**State Environmental Policy Act (SEPA)
MITIGATED DETERMINATION OF NON-SIGNIFICANCE (MDNS)**

File #: P21-126

Date: October 18, 2021
To: Stacey Henderson, Senior Planner
From: Craig Jones, Development Coordinator *CJ*
Through: Derek Mayo, City Engineer *DEM*
Re: Bull Rd – Mallard Meadows SEPA – P21-126

The following are the City Public Works SEPA comments for the proposed Mallard Meadows on the east side of Bull Rd N of I-90.

CITY OF ELLENSBURG
NATURAL GAS DIVISION
UTILITY MAP REQUEST INFORMATION

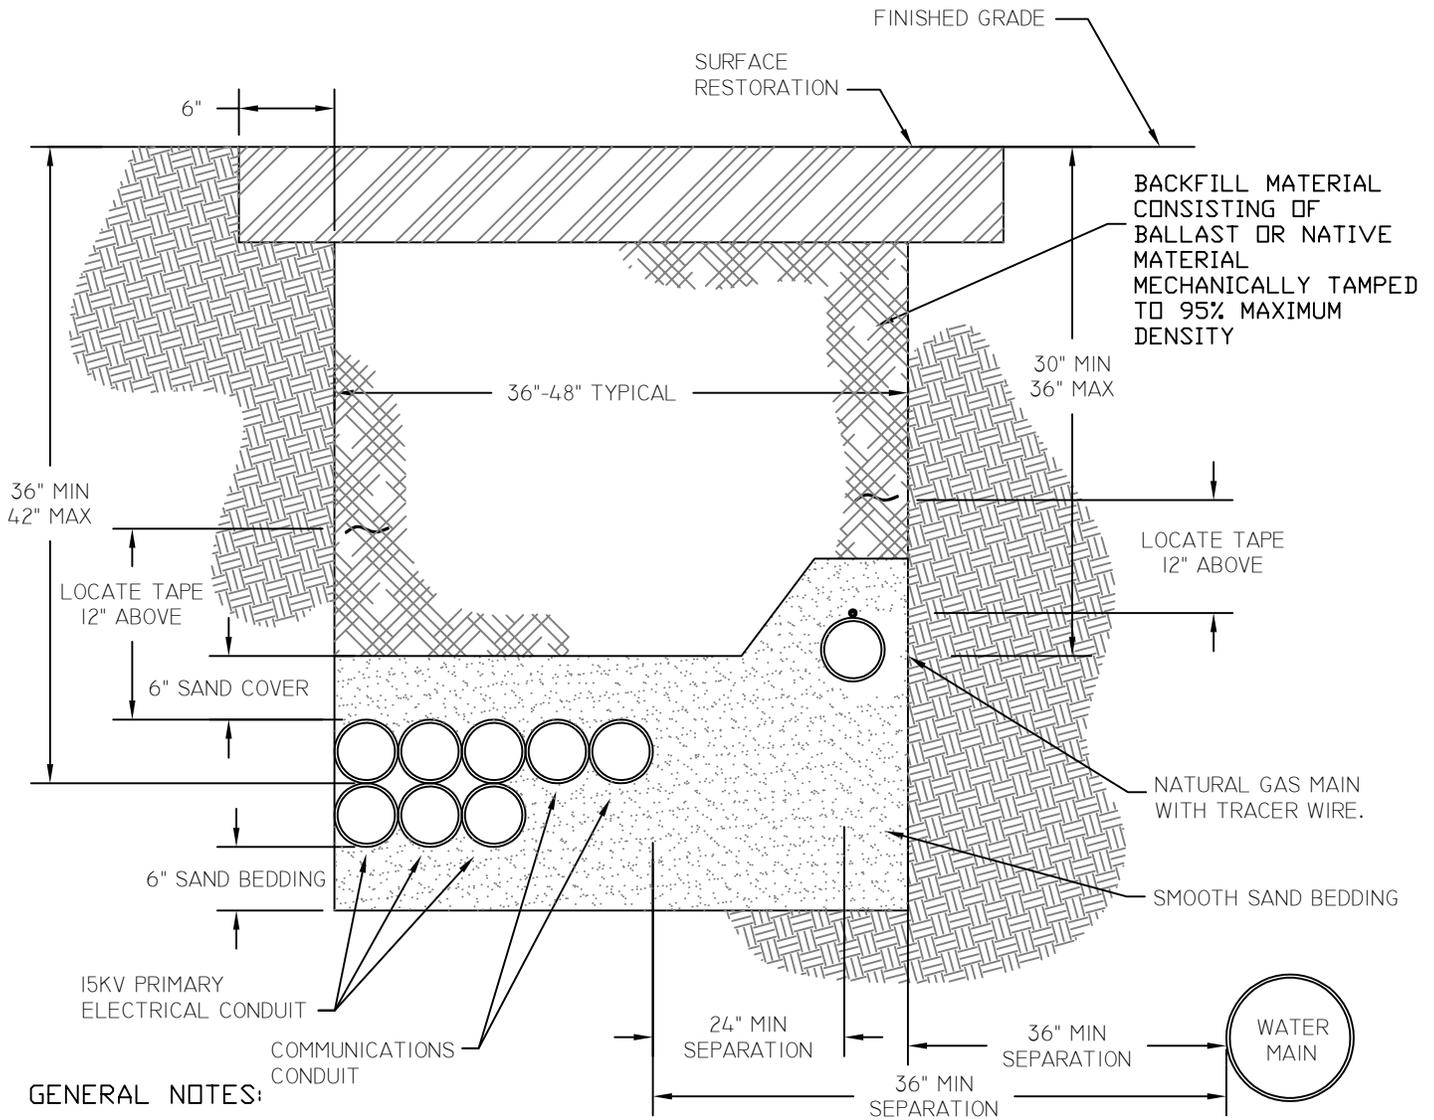
There is a natural gas utility map attached showing the existing gas main line. There is a 4-inch main that has recently been extended down Bull Road that would be used to serve the proposed development.

The proposed development would be required to extend the gas main throughout and provide service stubs to each lot. The main line on the two southern east/west main roads will need to be extended all the way east to the extents of the property and if not within right-of-way, they will need to be within an easement. It is preferred that the mainline be shown on the civil plans to help in planning and determining issues that may come up as the project progresses. No details will be needed, just the mainline shown where installation is being proposed.

**DISTRIBUTION
TRENCH REQUIREMENTS**

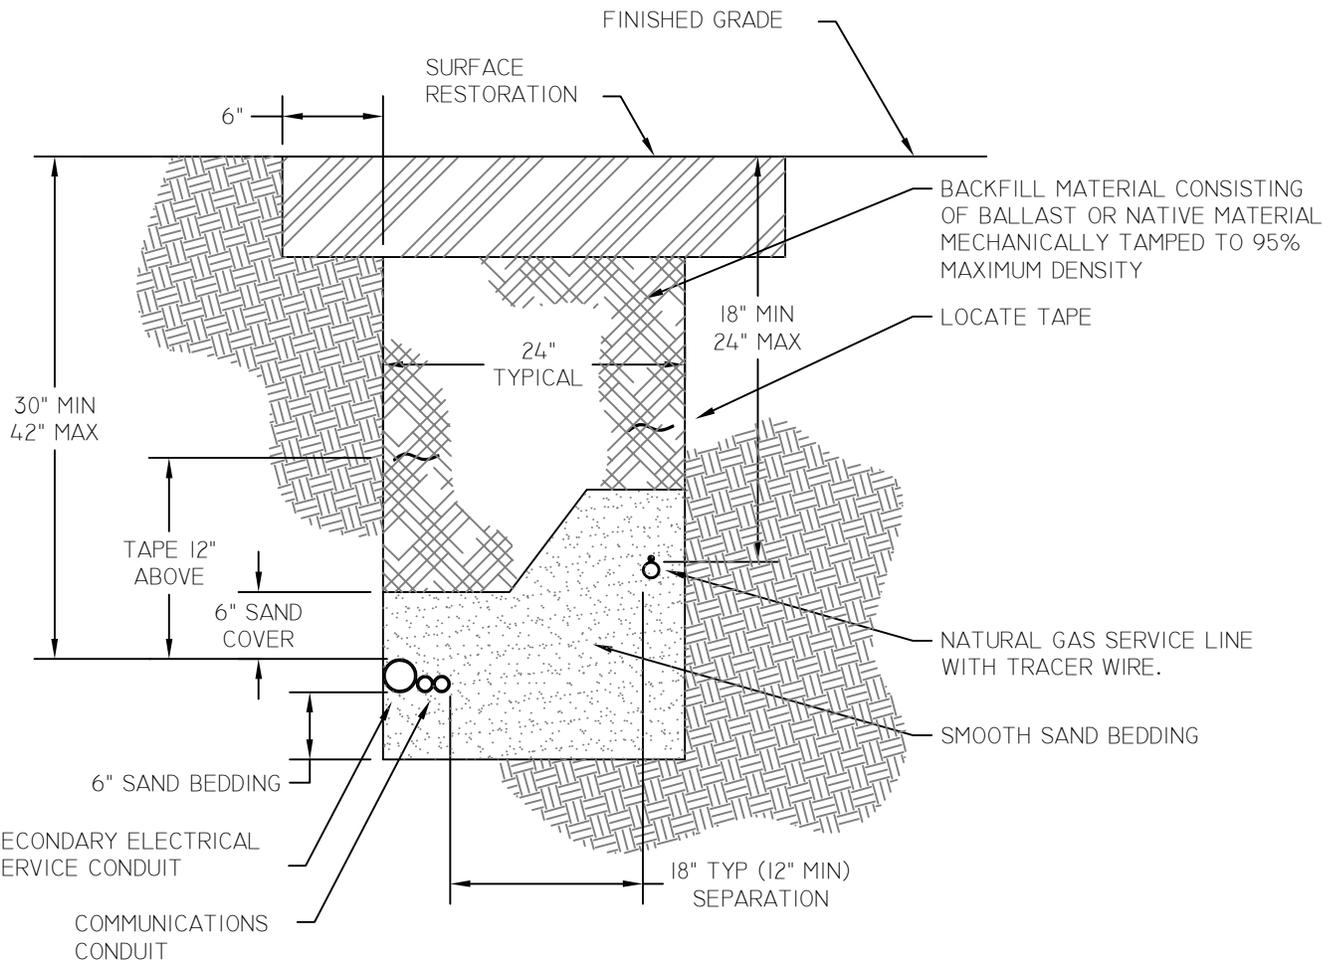
The applicant is responsible for exposing the main line for connection, providing trenching, smooth sand bedding, and backfill at the specified depth and required utility separation as indicated on detail sheets G-12 and G-13 attached. City Gas Division crews will provide the materials and perform the installation in the developer provided trenches.
